Beretta
A TRADITION OF EXCELLENCE SINCE 1526

1201 F / 1201 FP

The new model 1201 F offers important improvements in comparison to the previous model (1200 F).

Fig. 1

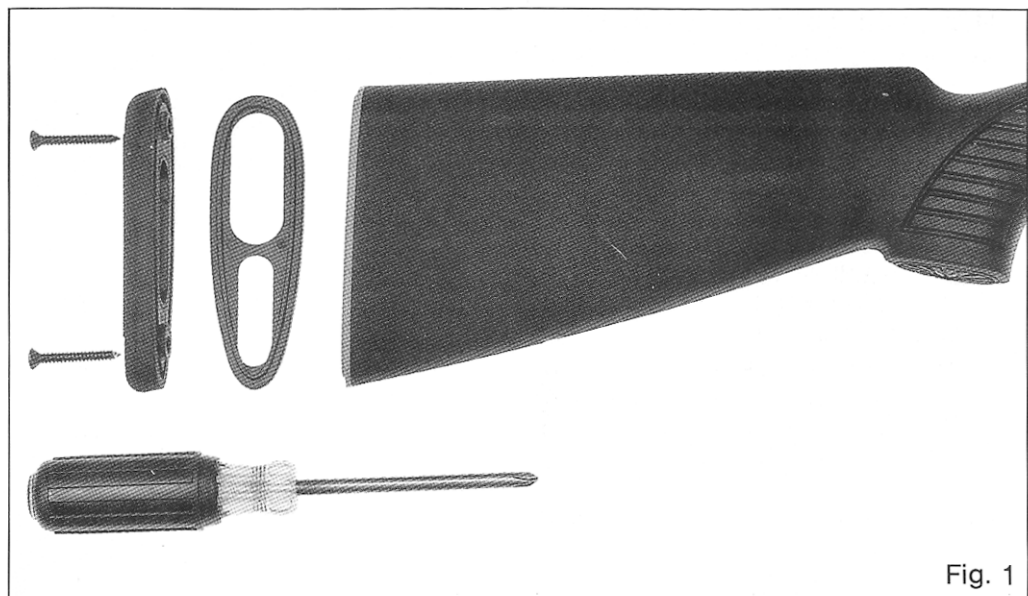
STOCK DROP MODIFICATION

Both models 1201 F and 1201 FP are normally factory set with a heel drop of 60 mm.

In order to modify the drop it is necessary to use the appropriate modification set consisting of a metal plate and a plastic spacer.

Available sets as follows:

- 60 mm. set (factory set)
- 55 mm. set on request
- 50 mm. set on request

It is advised to have the operation carried out by a competent gunsmith (use a 13 mm. hexagonal tube spanner, after removing rubber recoil pad with a medium sized cross-point screwdriver).
